# Staff Report PC22-024-DP

## Westpark Logistics Center Lot 2

### Docket PC22-024-DP – Development Plan – Westpark Logistics Center Lot 2

## Proposed Development

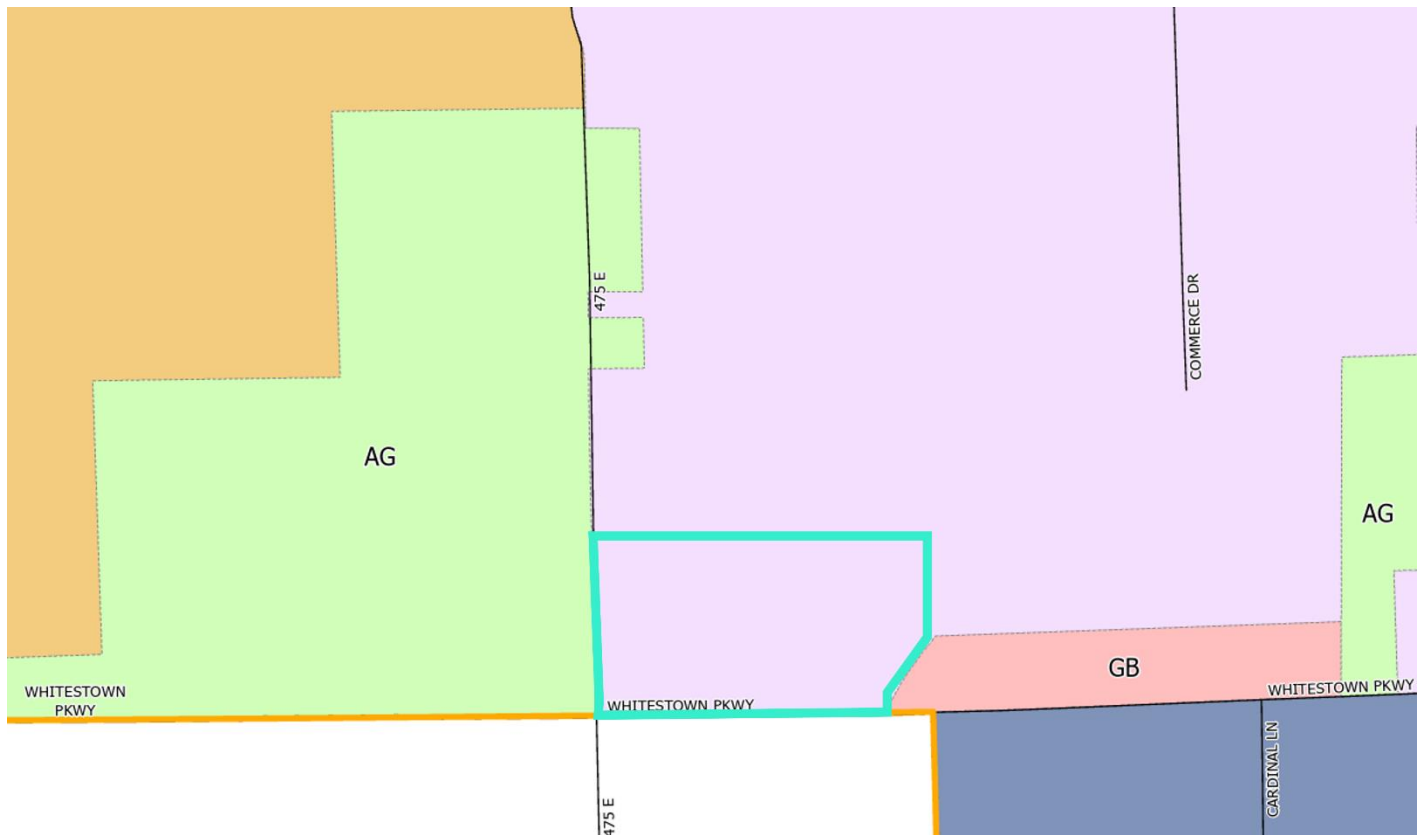
1. The applicant will construct a sidewalk along CR 475 E and a sidewalk connection from the CR 475 E sidewalk to the site's internal pedestrian network. Locations of the paths to be determined with the Public Works and Planning Departments.
2. Other TAC comments for the Public Works department will need to be addressed before site grading.
3. Additionally, the applicant will need to submit a revised landscaping plan that meets the requirements of the UDO before building permits.
